Letter - G4

Letter - G5. Signatory -Friends of the Van
Duzen.

Letter - G6. Signatory - www.freeyellow.com.

KRIS Coho
Area: Van Duzen
Topic: Sediment: Fines <0.85mm Van Duzen Tribs 1996-2001

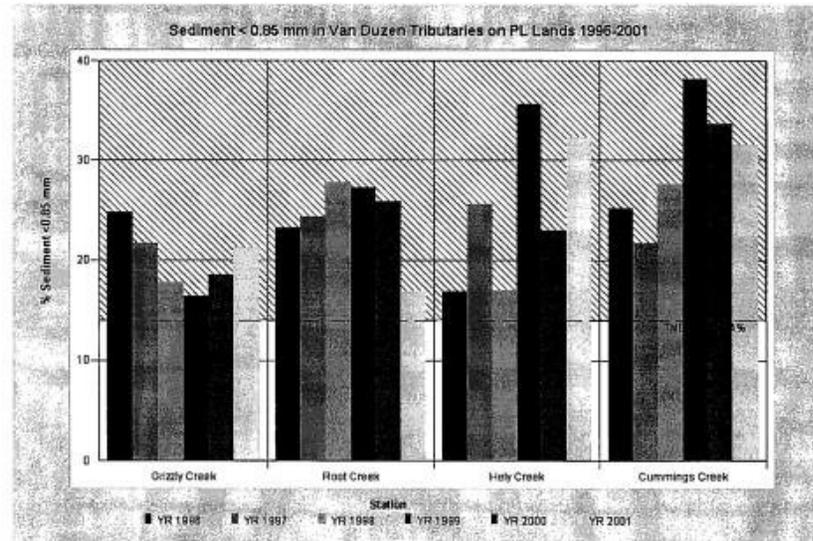
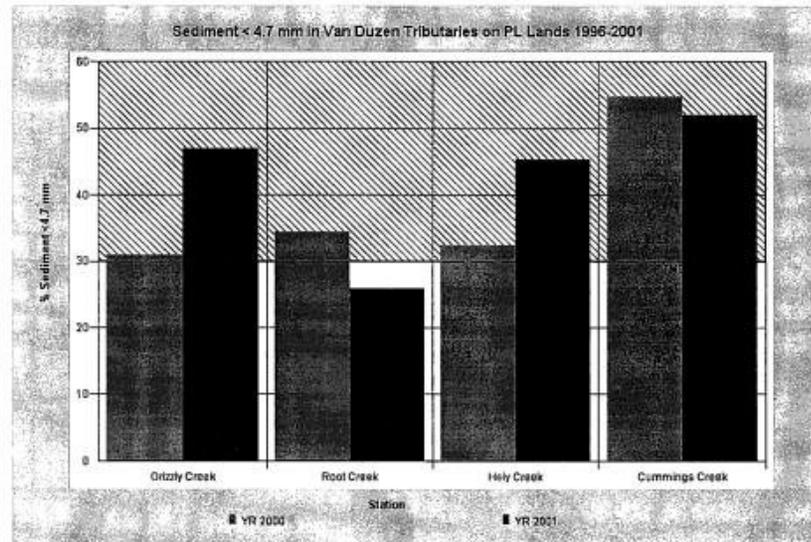
The percentage of fine sediment less than 0.85 mm in all Van Duzen River tributaries draining PALCO lands is higher than thresholds set by the U.S. Environmental Protection Agency for the Garcia River (14%) in all years since 1996. Hely and Cummings Creek have extremely high fine sediment in this size class indicating active sediment sources. Fine sediment levels in all these streams

The Simpson study does not adequately address the problem of sedimentation in the Van Duzen River Watershed. It does not adequately address the TMDL issue. According to the Kelsey study, the Coastal Range is the most erosive in all of North America. How does Simpson justify their policy of continued clear cutting in the Van Duzen Basin, and the discharge of sediment into the rivers and tributaries. How does the SYP address the need for monitoring stations to measure sediment discharge in an impaired watershed? Further studies of fine sediment on Palco lands show the following.

The Plan recognizes the regulatory status of the Van Duzen under the CWA Section 303(d) process as water quality limited for sediment. AHCP/CCAA Section 4.3.6, Table 4-3. The existing sediment load is a baseline condition (see Master Response 1) and the potential for increased sediment input has been identified as a potential impact to the covered species and their habitats (AHCP/CCAA Section 5.3; Appendix E). AHCP/CCAA Section 6.1.2.2.4 includes a biological objective for reducing sediment delivery into watercourses. This and the other biological goals and objectives set forth in AHCP/CCAA Section 6.1 were used to guide development of specific measures that are included in the Operating Conservation Program (AHCP/CCAA Section 6.2). Implementation of the Operating Conservation Program will minimize and mitigate the impacts of take to the maximum extent practicable and ensure that such take will not appreciably reduce the likelihood of survival and recovery of the covered species in the wild. See Master Response 8. If results of the monitoring program (AHCP/CCAA Section 6.2.5) demonstrate that adjustments to the Operating Conservation Program are necessary, the adaptive management program (AHCP/CCAA Section 6.2.6) provides a mechanism to adjust the conservation measures. See AHCP/CCAA Section 6.3.5.1.2 regarding the “feedback loop” between the Monitoring Program and the Adaptive Management Program.

The commenter wants to know how the Plan addresses the “TMDL issue.” To the Services’ knowledge, Green Diamond has not applied for any CWA or State Porter-Cologne Act approvals uniquely associated with TMDLs. However, as discussed above, the Plan has taken into account water quality issues associated

Graph prepared by Robert Brothers, Legacy - TLC, for Comments by the Friends of the Van Duzen, 9/13/02
See Appendix 6, Tables 3-5 for related numerical data.

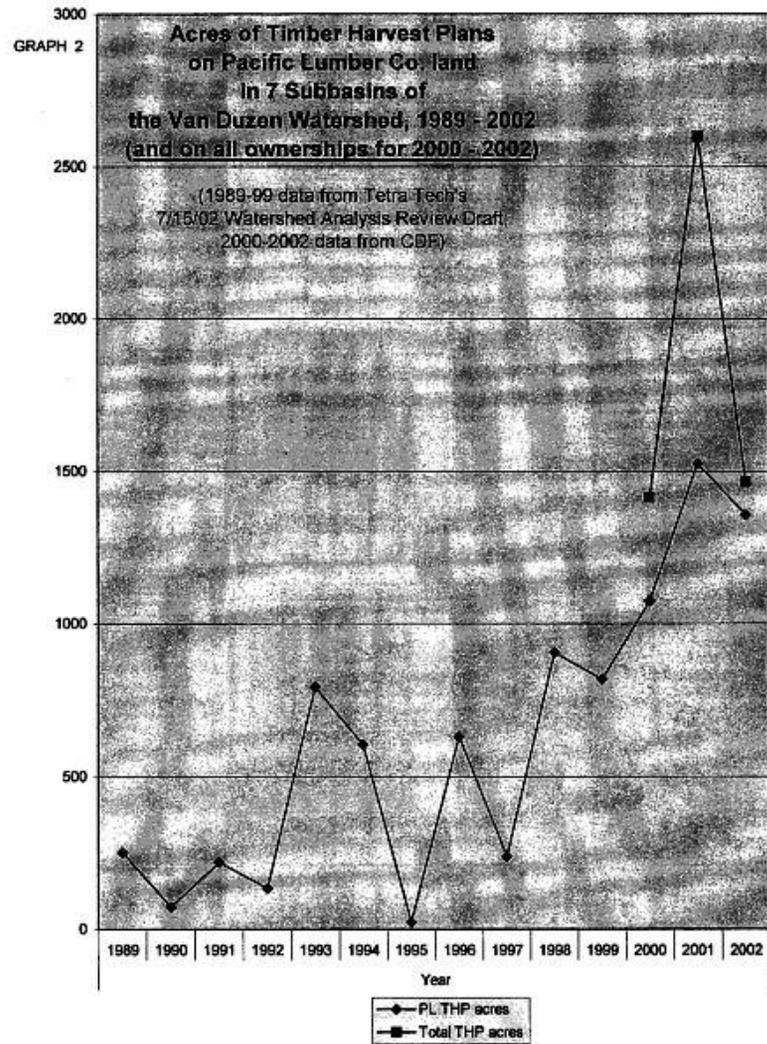
G5-7 The following is a graph developed by Legacy using the latest information from the California Dept. of Forestry GIS maps of timber harvest activities from 1989-2002. Notice the tremendous increase in cutting in 2001. What level of timber harvest can be expected from Simpson? What means will be taken to restore the watershed? At what level will Simpson be able to log the watershed?

See Master Response 11.

Based upon information provided in AHCP/CCAA Section 4.4.11 and Table 1-1, that the Van Duzen River falls within the Eel River HPA, and that there are approximately 205,000 acres in the HPA, of which 8,000 acres are currently within the Plan Area. Presumably, nearly all of this commercial timberland will be harvested by Green Diamond sometime within the 50-year term of the Permits, since Green Diamond’s rotation age is slightly more than 50 years on average (see AHCP/CCAA Section 2.4). The Plan identifies excess sediment inputs from geologically unstable areas resulting in aggraded channels and embedded substrates as a significant factor limiting achievement of properly functioning habitat within this HPA. As described in AHCP/CCAA Section 7, implementation of the Plan is expected to contribute toward improvement of that condition.
